**From:** [Alison Kennedy](#)  
**To:** [Hayley Smith](#)  
**Cc:** [Abigail Murphy](#)  
**Subject:** RE: South West Rugby Design Code  
**Date:** 27 May 2025 12:31:01  
**Attachments:** [image001.png](#)  
[image002.png](#)  
[image003.png](#)  
[image004.png](#)  
[image005.png](#)  
[image006.png](#)

**The Town and Country Planning (Local Planning) (England) Regulations 2012  
South West Rugby Design Code Supplementary Planning Document public  
consultation**

Catesby Estates' Consultation Response Table to the South West Rugby Design Code SPD (February 2025)

Illustrative Mark-Up of Draft Building Heights Diagrams for Scenarios 1 and 2 on page 73 of the Draft for Consultation (10 February 2025) of the South West Rugby Design Code Supplementary Planning Document

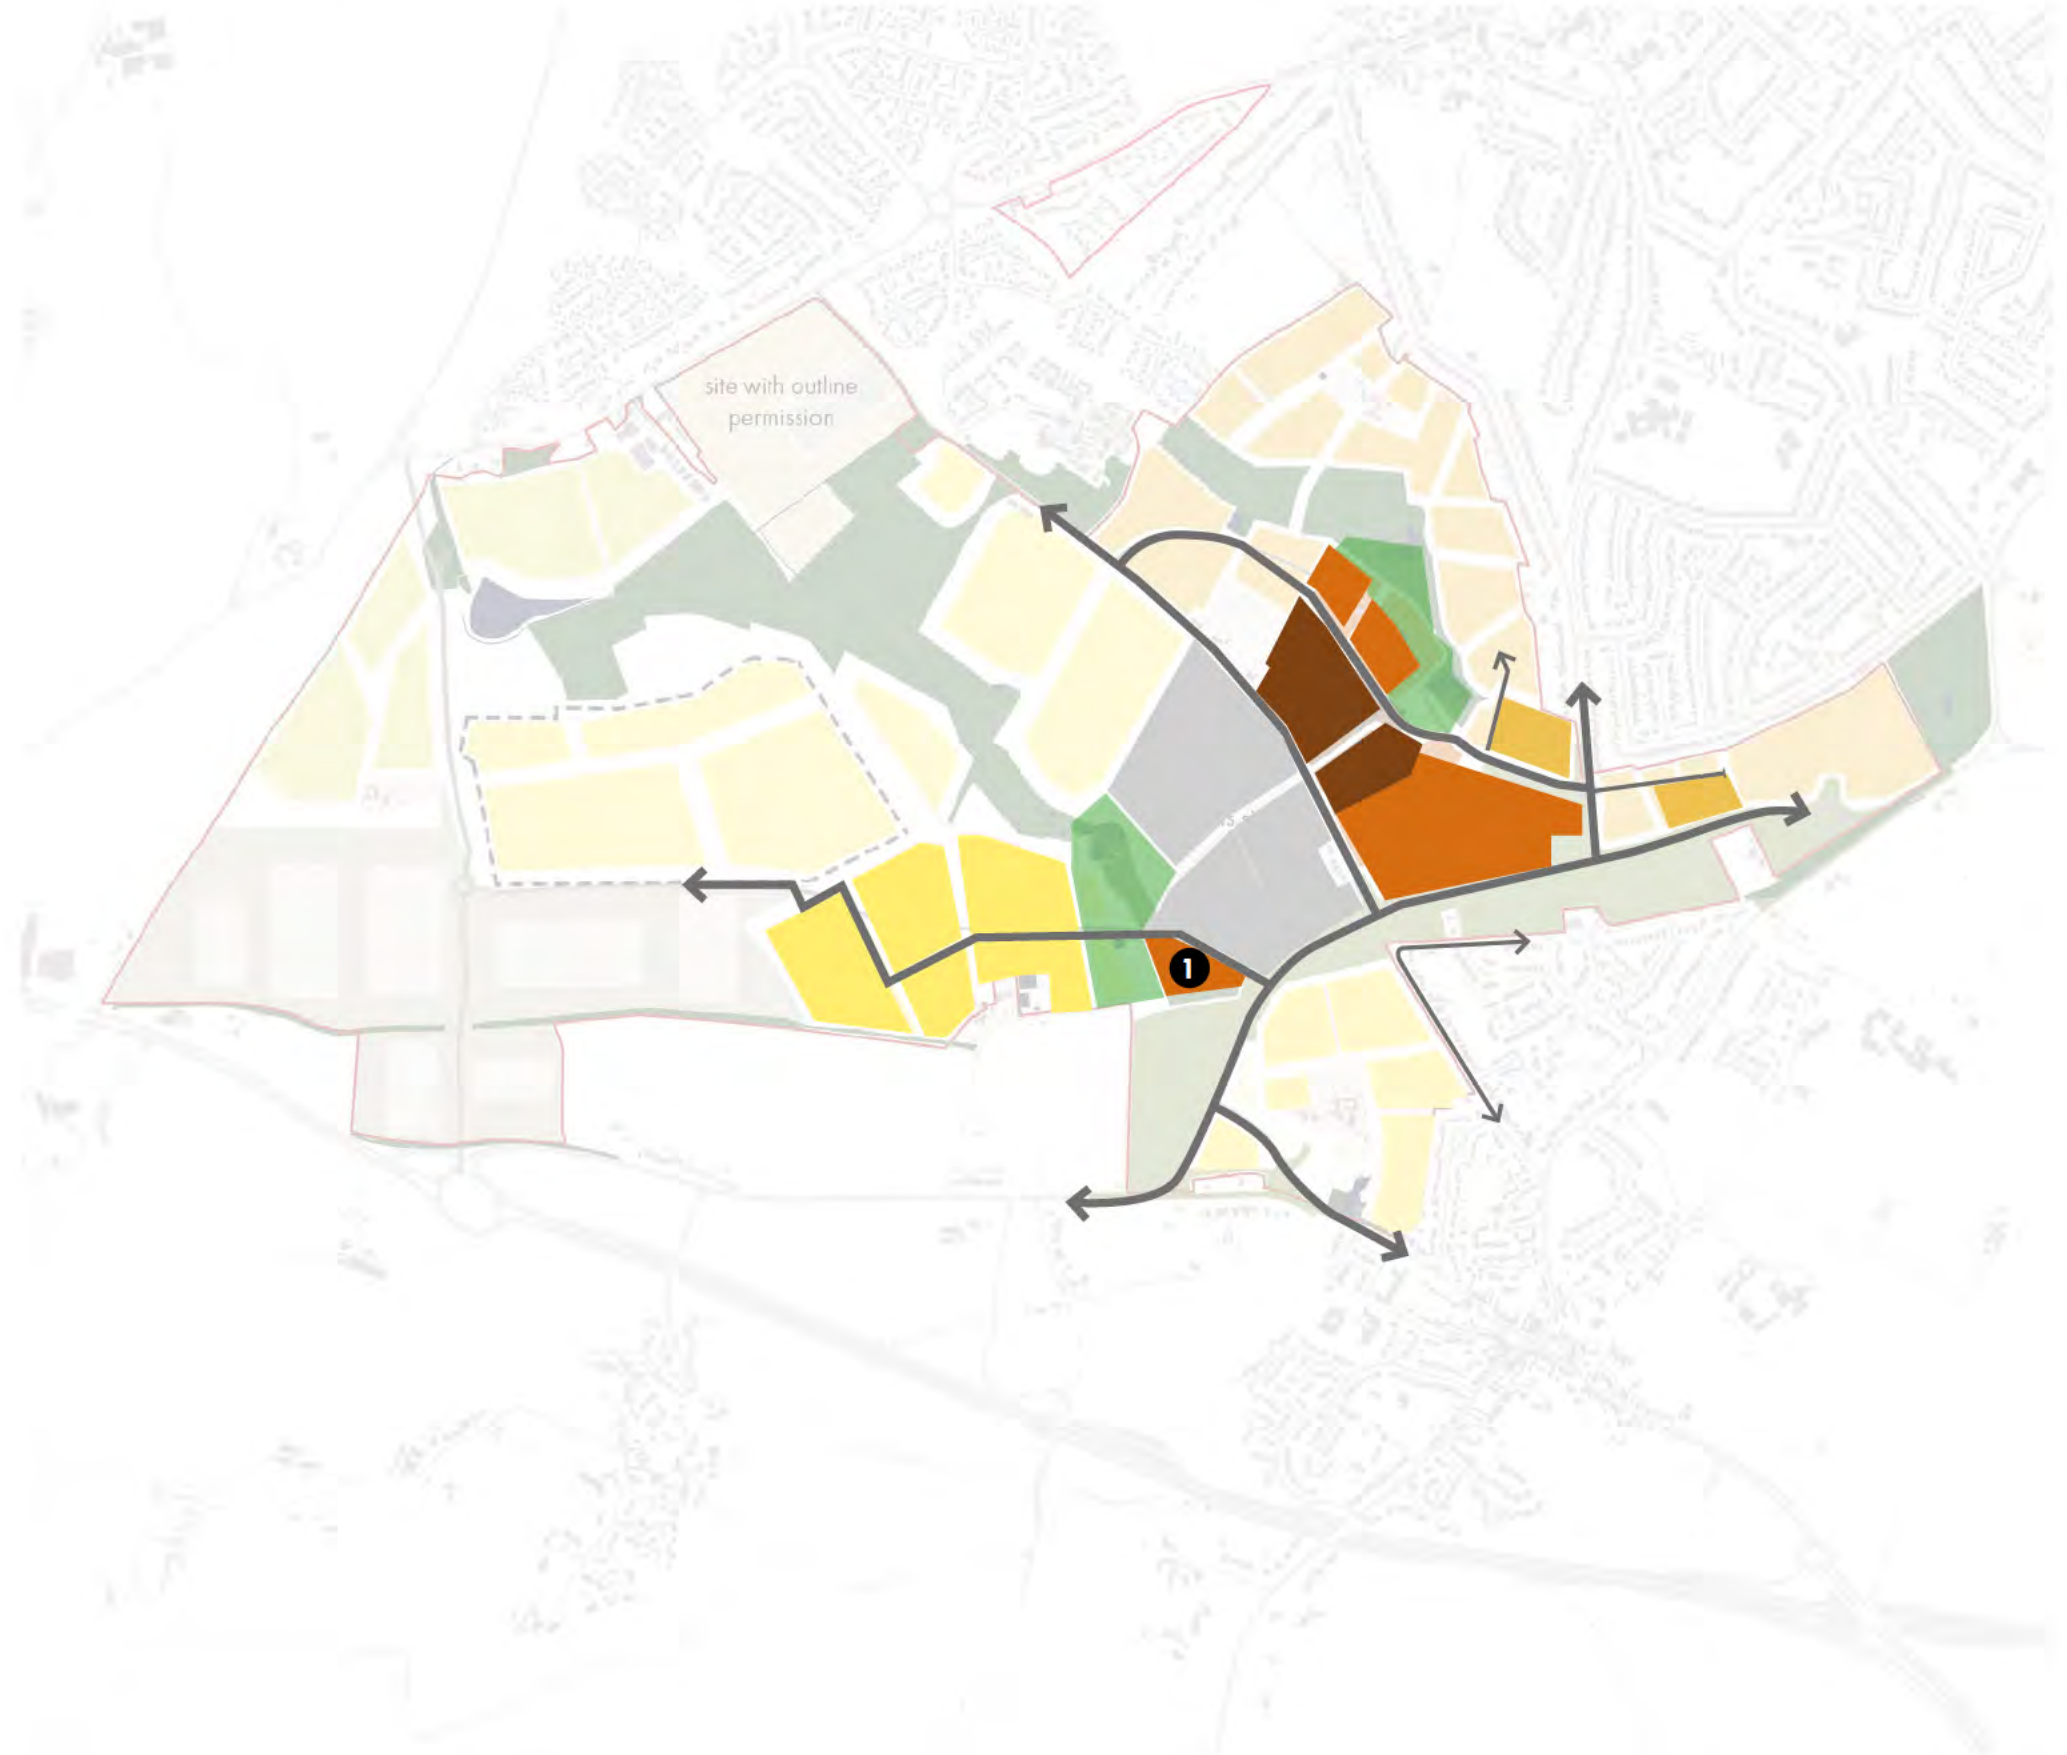
- 5** Suggest this zone is dropped in Scenario 2 to align with the drop in building heights that are proposed to its north along Cawston Spinney or enable an appropriate transition between the residential development to the east and south, and the potential employment area.

- 6** Development area within safeguarded land Scenario 2 should be set back to allow for a landscape and acoustic buffer between employment land and residential to the west and south.

# Suggested Update of the Residential Area Types (page 74)

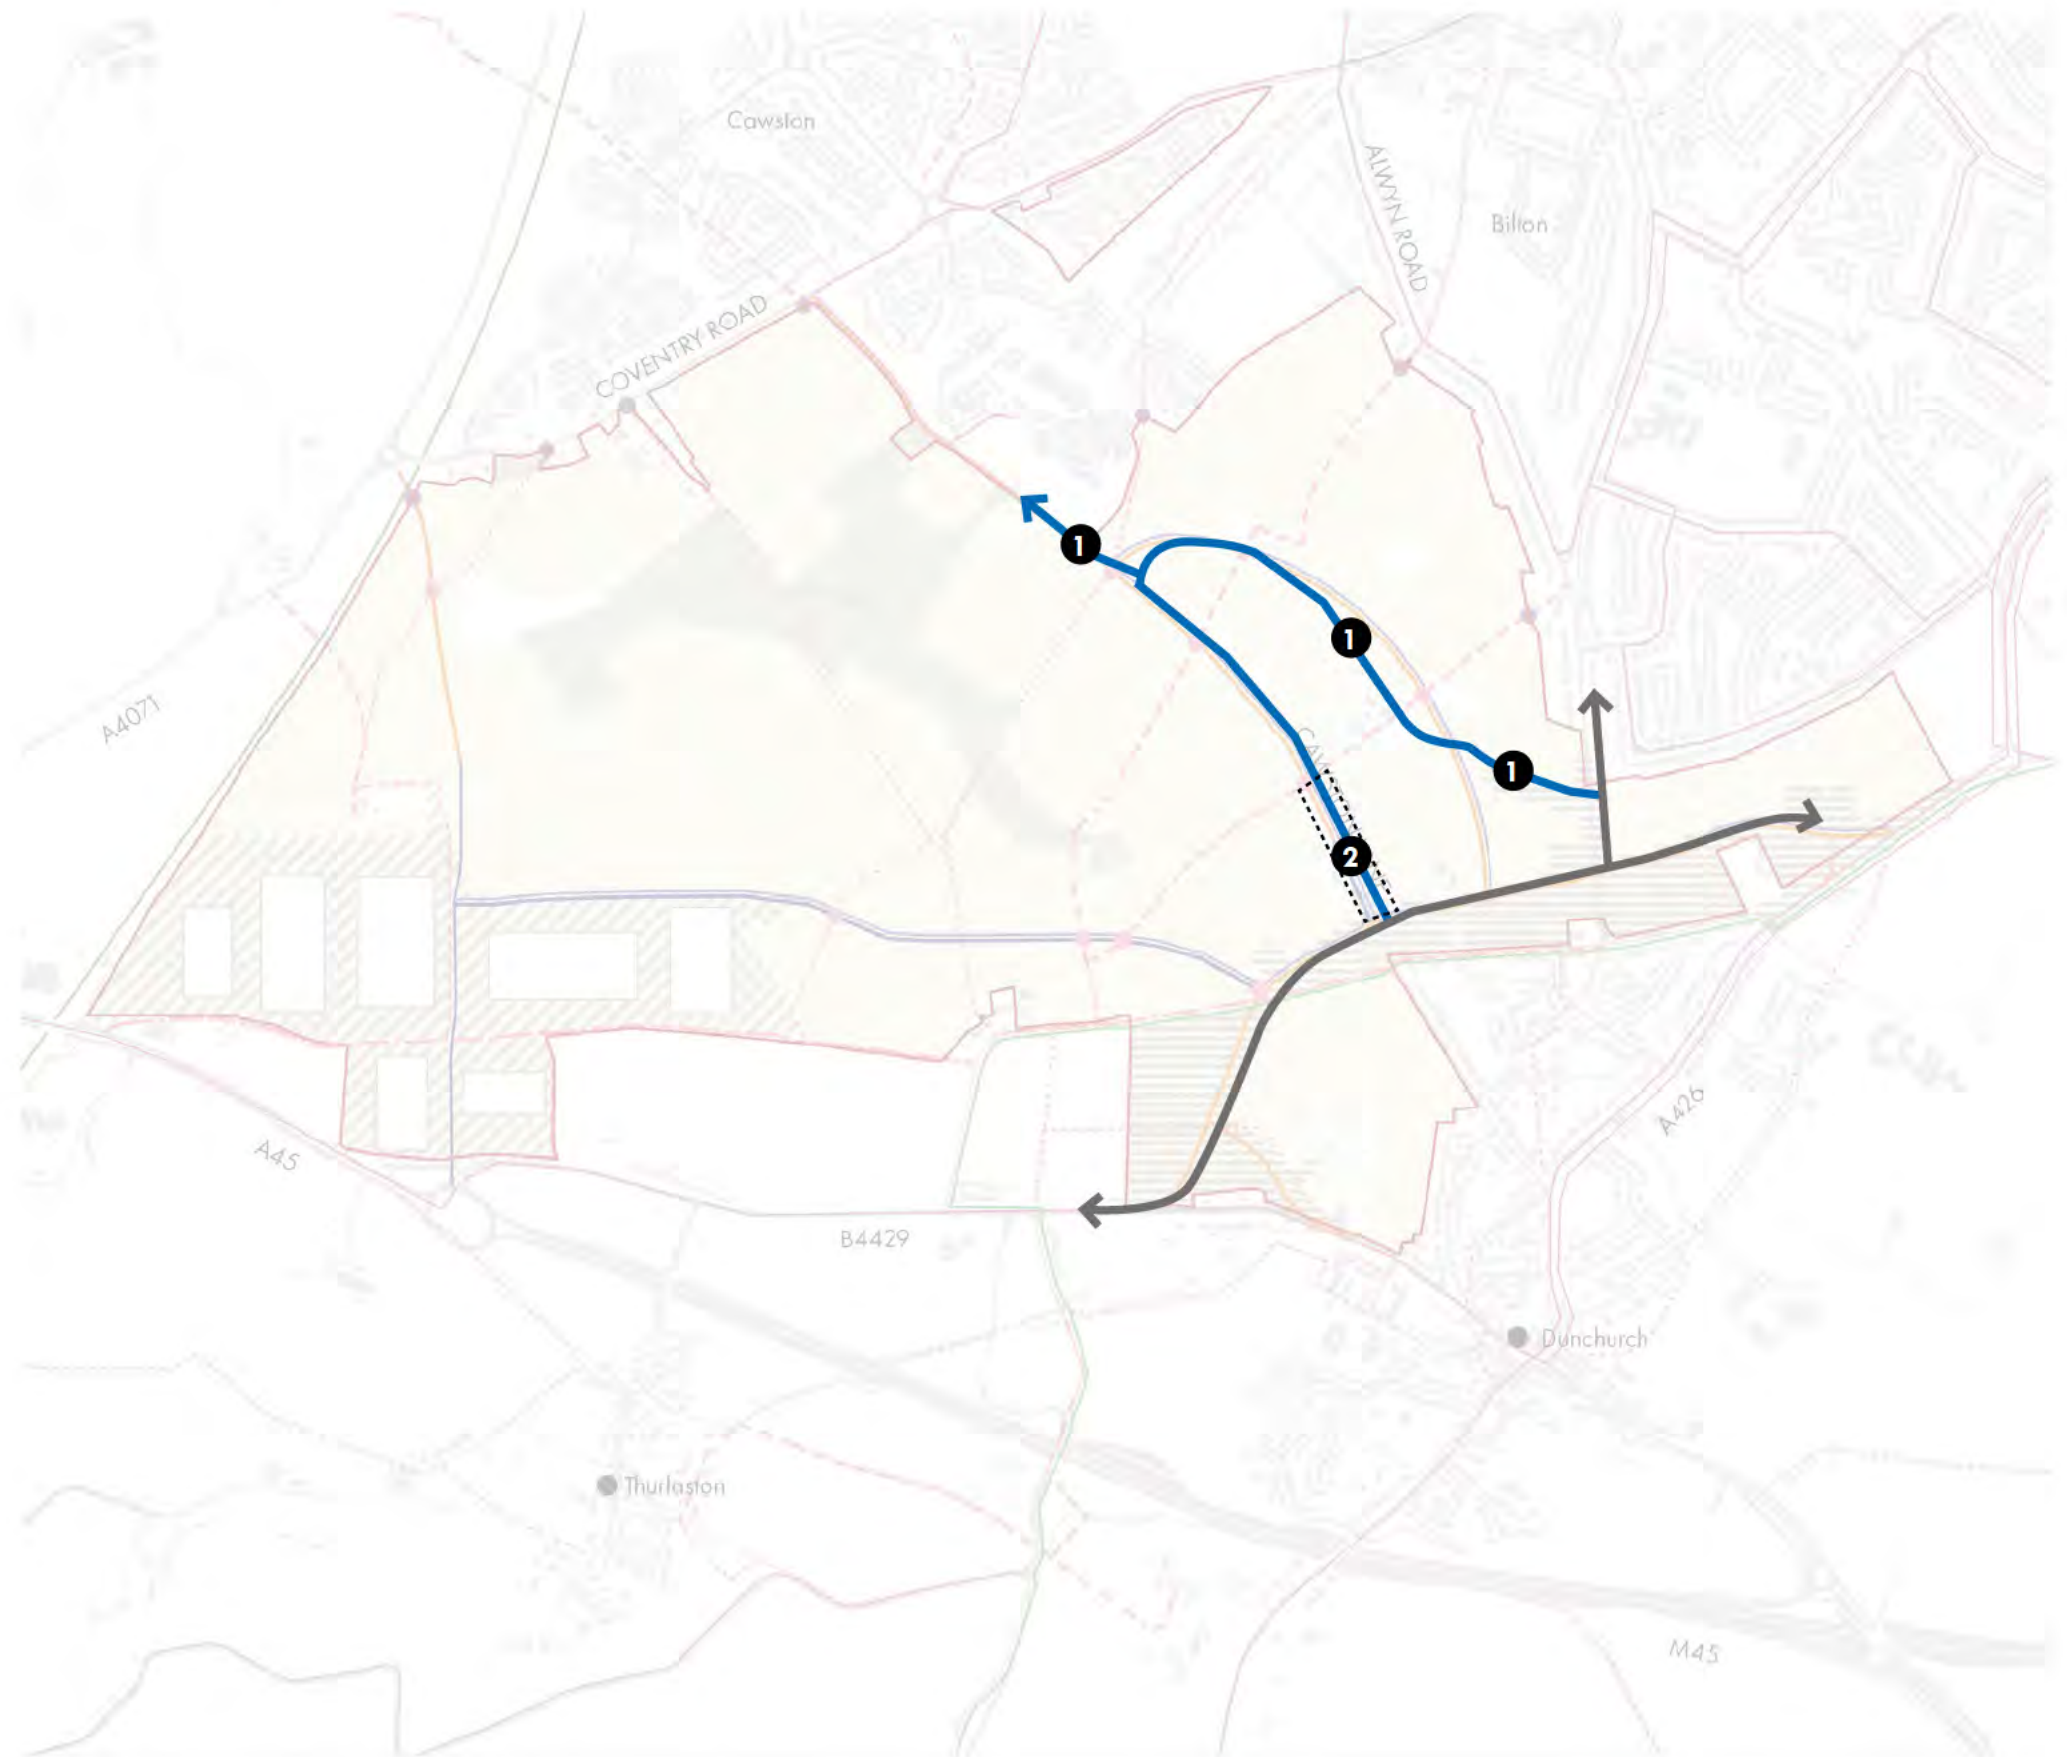
- 1** Suggest this parkland edge is moved to align with the suggested revision to the development parcel as per our other Framework Masterplan comments.
- 2** Suggest this part of the Homestead Link Road Edge is removed given our suggested amendment to the Framework Masterplan in this location.
- 3** Suggest the Homestead Link Road Edge is continuous across this development parcel.
- 4** Suggest the parkland edge is removed here as there will need to be a road between the development parcel and the open space as our emerging proposals have indicated.

### Secondary streets

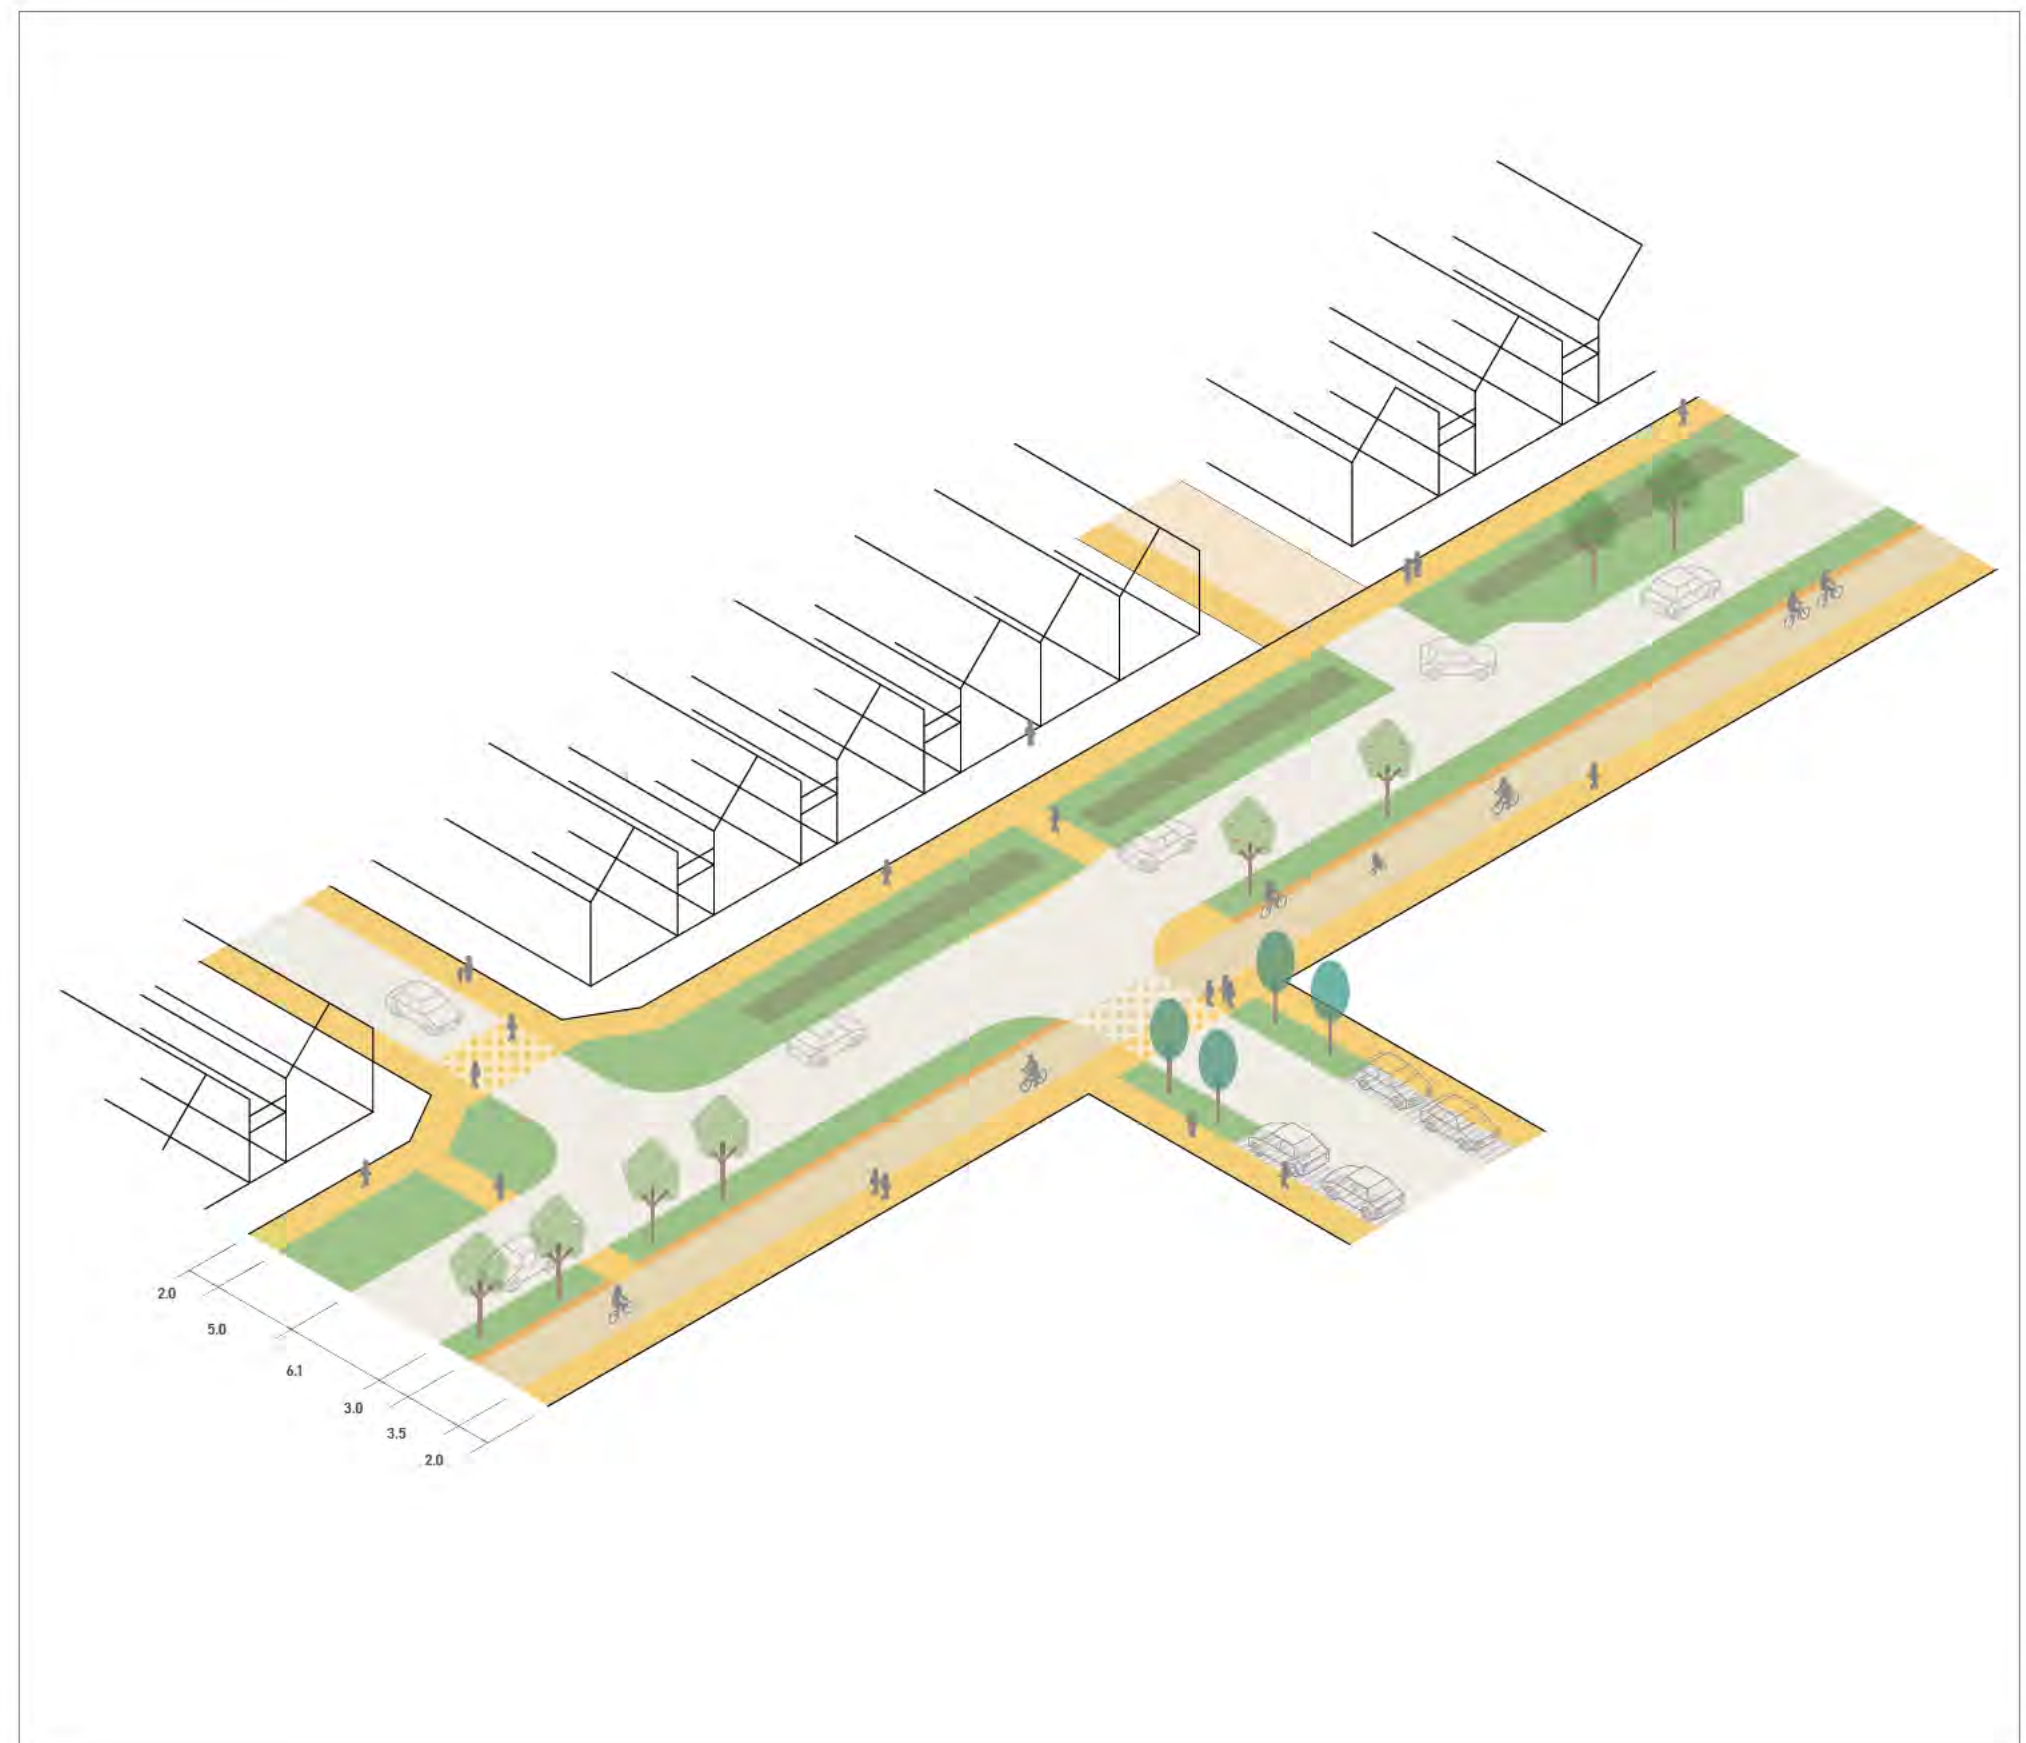
- p56 image – doesn't need 0.5 separation strip/ buffer
- p56 image – please add a gap opposite the side road so that cyclists can transition from the side road (on-carriageway) to the cycle track (off-carriageway) as done in Coundon Cycleway Coventry (photo attached)  
<https://maps.app.goo.gl/wNNjfupS488FpASb9>

- p56 image – doesn't need 0.5 separation strip/ buffer
- p56 image – please add a gap opposite the side road so that cyclists can transition from the side road (on-carriageway) to the cycle track (off-carriageway) as done in Coundon Cycleway Coventry (photo attached)  
<https://maps.app.goo.gl/wNNjfupS488FpASb9>
